ADDENDUM NO. 1

DARKE COUNTY PARKS NATURE CENTER ROOF REPLACEMENT May 17, 2021

Re: Darke County Parks - Nature Center Roof Replacement

TYPICAL MONO-SLOPED ROOF CAP DETAIL

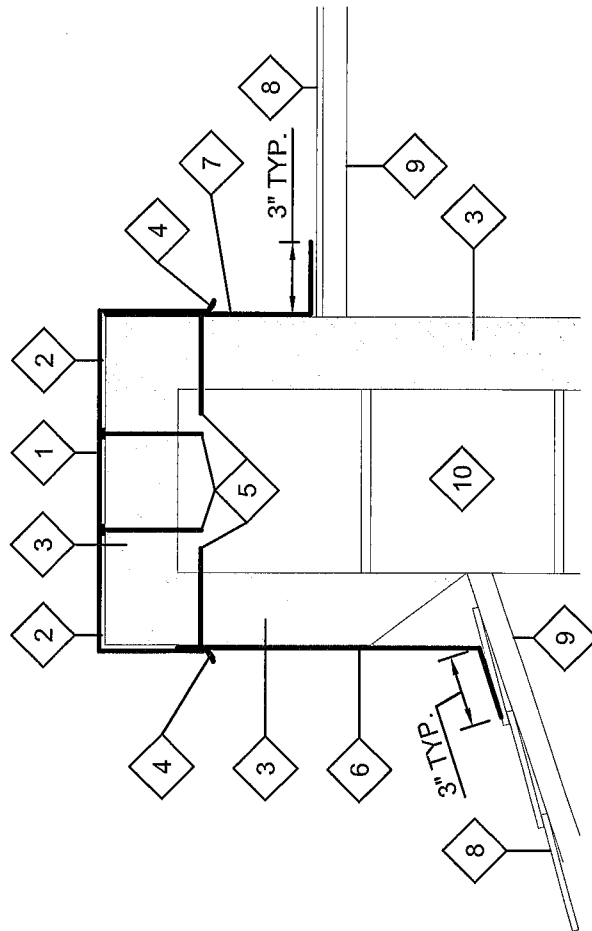
- A. The Base Bid Roof Replacement has been revised to include materials and installation of counter flashing and a roof cap system (see attached "Flashing Details"). Cost for removal and disposal of the existing flashing and counterflashing shall also be included in the Base Bid.

2. The Engineer's Base Bid Estimate has been revised to \$70,500 to address flashing, counterflashing, and cap work as indicated in the sketches provided and identified in 1A above.

1. 24 GAUGE CAP SYSTEM WITH BROWN KYNAR FINISH TO MATCH EXISTING.
2. 24 GAUGE CONTINUOUS INNER SNAP CLEAT.
3. EXISTING 3" THICK EIFS SYSTEM.
4. ANGLED DRIP REQUIRED TYP.
5. PROVIDE GALVANIZED ANCHOR SYSTEM THROUGH 3" EIFS SYSTEM AS APPROVED BY ENGINEER. ANCHORS TO BE INTO TREATED LUMBER OR MASONRY AS EXISTING CONDITIONS WARRANT.
6. 24 GAUGE FLASHING.
7. 24 GAUGE STEPPED FLASHING.
8. ASPHALT SHINGLES ON UNDERLAYMENT.
9. EXISTING TECTUM DECK.
10. EXISTING MASONRY BLOCK OR WOOD FRAMED WALL.
11. EXISTING TRUSS.
12. EXISTING SHEATHING.
13. PROPOSED 24 GAUGE MONO-PITCH ROOF CAP.
14. PROPOSED 1" WIDE x 3/8" THICK BUTYL TAPE.
15. PROPOSED 3" RINGSHANK GALVANIZED FASTENER SEALED WITH ELASTOMERIC CAULK.
16. PROPOSED ELASTOMERIC CAULK.
17. PROPOSED 1/2" HEM.
